CLIENT
Haley Sharpe Design Ltd
PROJECT
Wrexham Museum Redevelopment
JOB NUMBER
241084

TITLE
Ground Floor General Arrangement
Floor Finishes Plan

DRAWING NAME
241084-PUR-00-GF-DR-A-2650

1 / 2650 **Proposed Floor Finishes Ground Floor**
1:100 @ A1

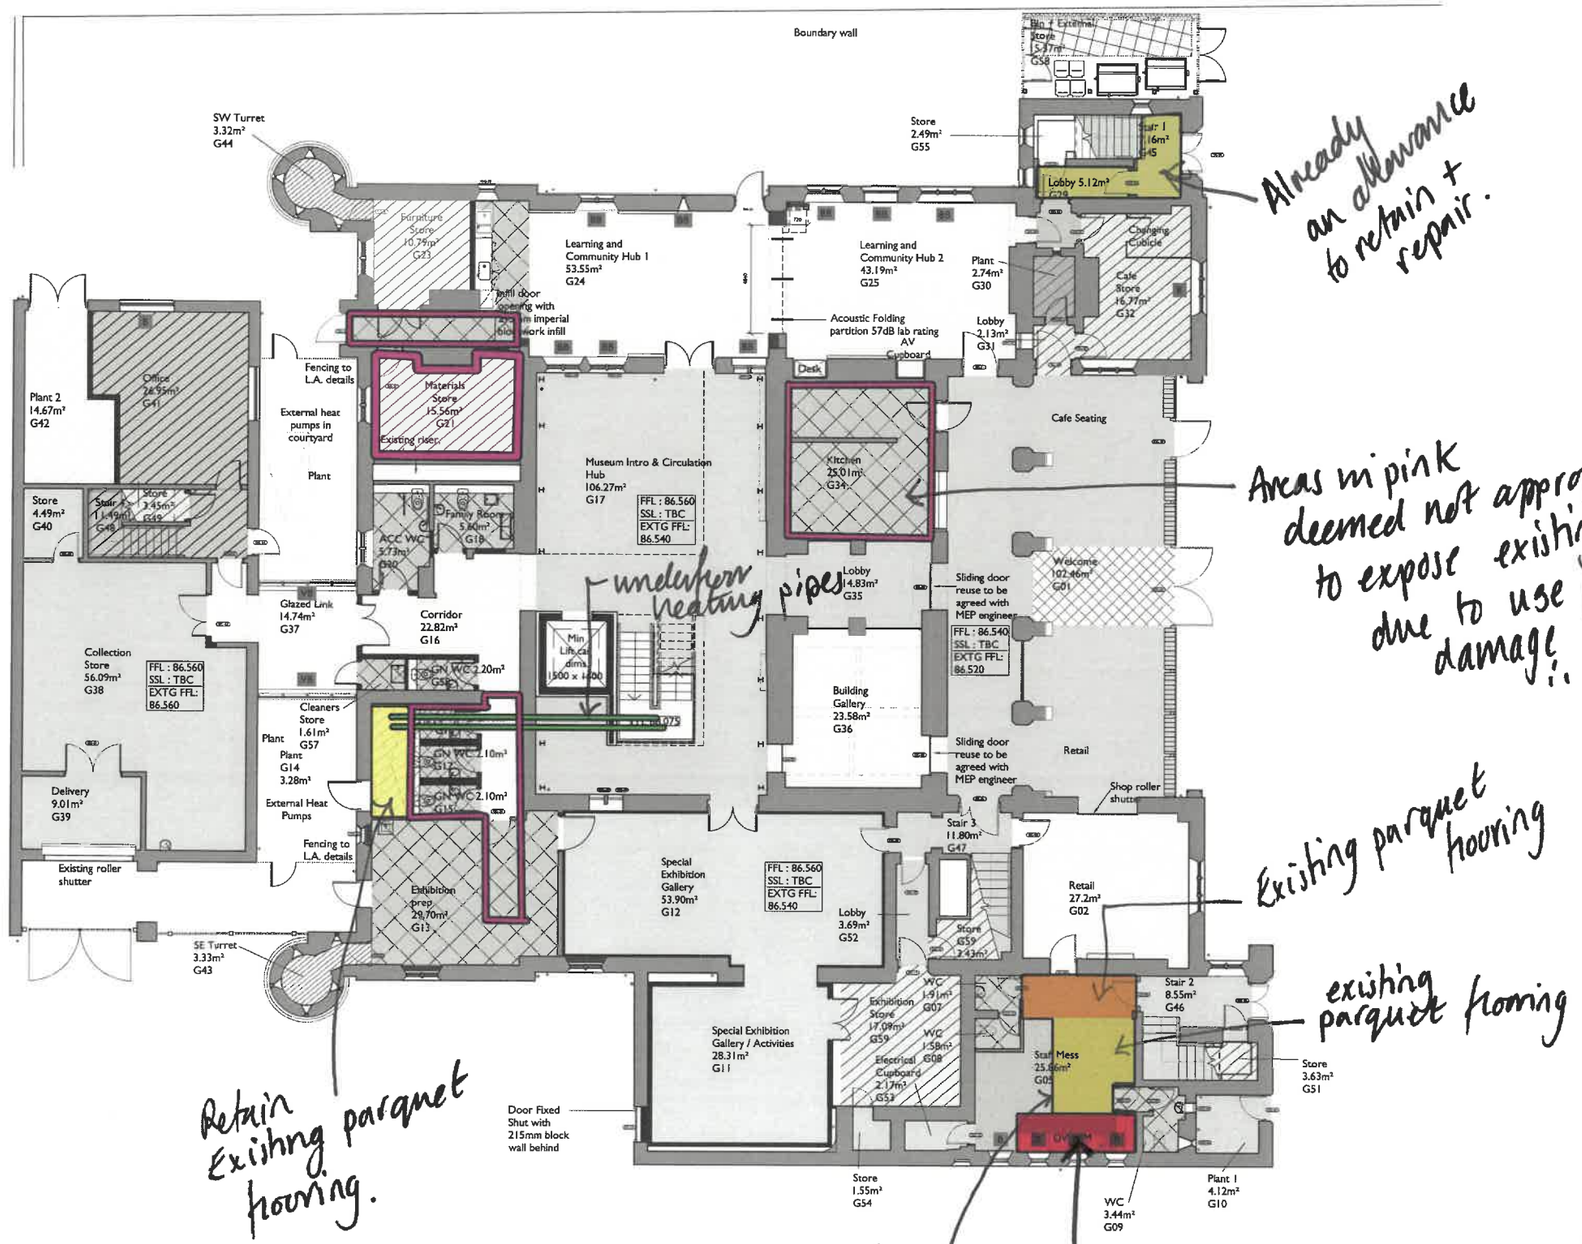
Already an allowance to retain + repair.

Areas in pink deemed not appropriate to expose existing flooring due to use / avoidance of damage.

underfloor heating pipes

proposed new flooring to sit on top of existing

Existing parquet flooring

existing parquet flooring

Retain Existing parquet flooring.

rubber edge (approx 10mm) between new and existing flooring

vinyl around kitchen cabinets.
